**A RESOLUTION OF THE CITY COUNCIL OF
THE CITY OF MERCED, CALIFORNIA,
ADOPTING THE MERCED VISION 2030
GENERAL PLAN**

**MERCED VISION 2030 GENERAL PLAN
OPTION 3**

Proposed Changes Since August 2010 Public Review Draft

**MERCED VISION 2030 GENERAL PLAN
OPTION 3**

UC Merced Campus & University Community North Land Use Map

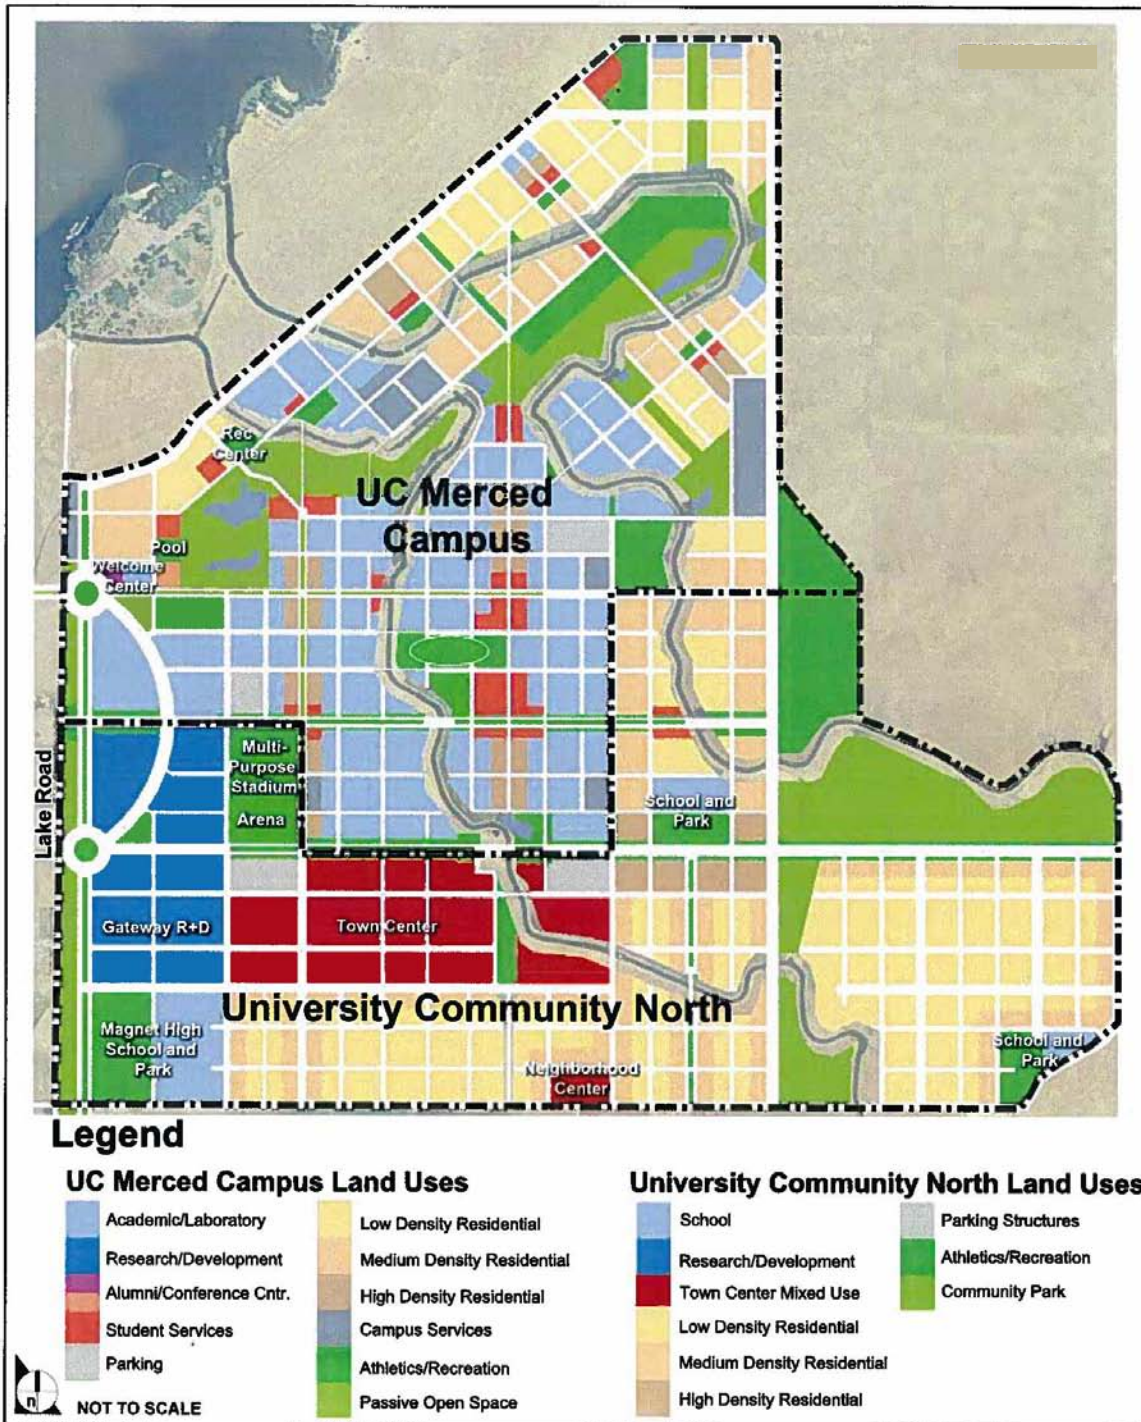
#	Pg.	¶	Col.	Change	Source
1	--	--	--	Various Figures, Maps, and Table throughout the General Plan document will be modified to reflect the 2009 UC Merced and University Community North boundaries as adopted by the UC Board of Regents in 2009. This will include changes to the Land Use Diagram and SUDP/SOI boundary for those areas only. See Exhibit 1 for the 2009 UC/UCP boundaries.	CS/UC

Figure 4.27f
Yosemite Avenue (East of Parsons/Gardner) Special Section

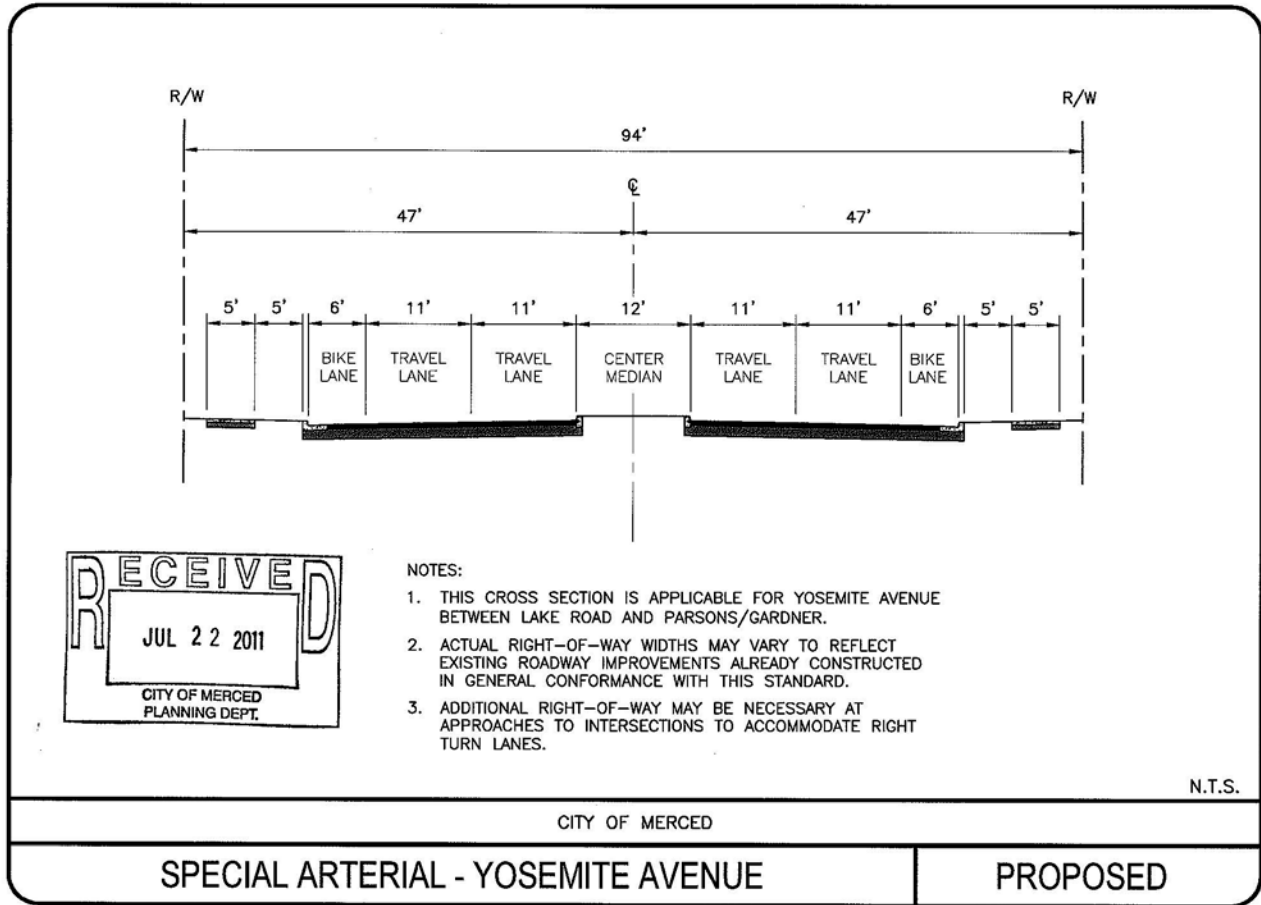
- NOTES:
1. THIS CROSS SECTION IS APPLICABLE FOR YOSEMITE AVENUE BETWEEN LAKE ROAD AND PARSONS/GARDNER.
 2. ACTUAL RIGHT-OF-WAY WIDTHS MAY VARY TO REFLECT EXISTING ROADWAY IMPROVEMENTS ALREADY CONSTRUCTED IN GENERAL CONFORMANCE WITH THIS STANDARD.
 3. ADDITIONAL RIGHT-OF-WAY MAY BE NECESSARY AT APPROACHES TO INTERSECTIONS TO ACCOMMODATE RIGHT TURN LANES.

Land Use Diagram - Option 3 Sectors for Adoption

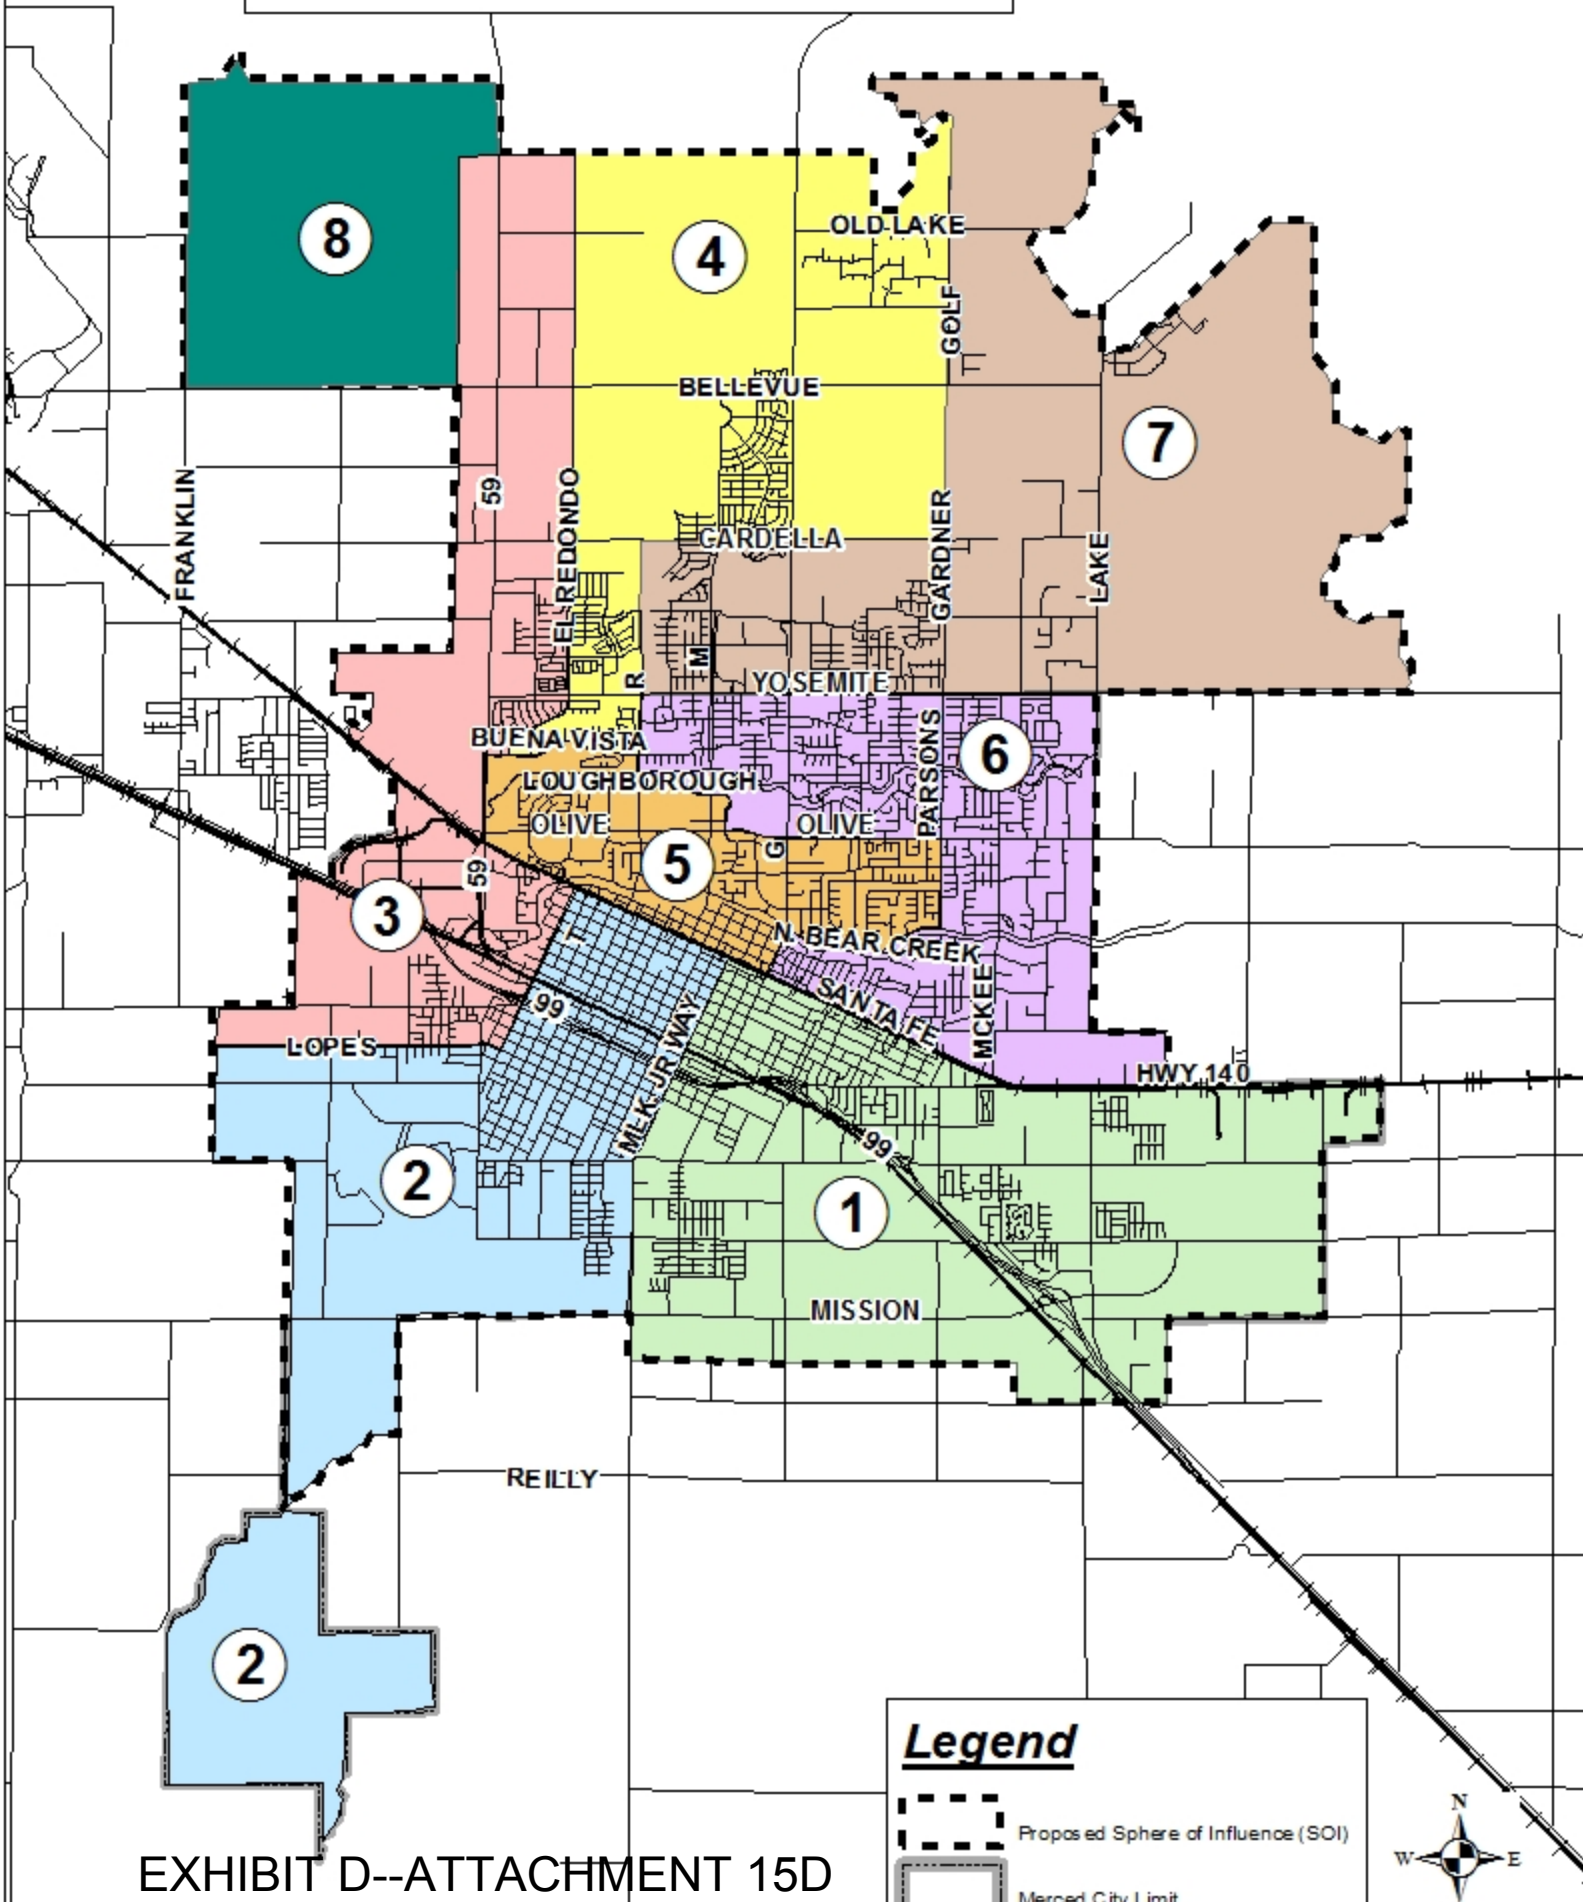
SECTION 3. The *Merced Vision 2030 General Plan* Land Use Diagram (Modified Figure 3.1 of Exhibit A) as divided into the eight sectors outlined in Exhibit D and with the changes as outlined in Exhibit C is hereby adopted.
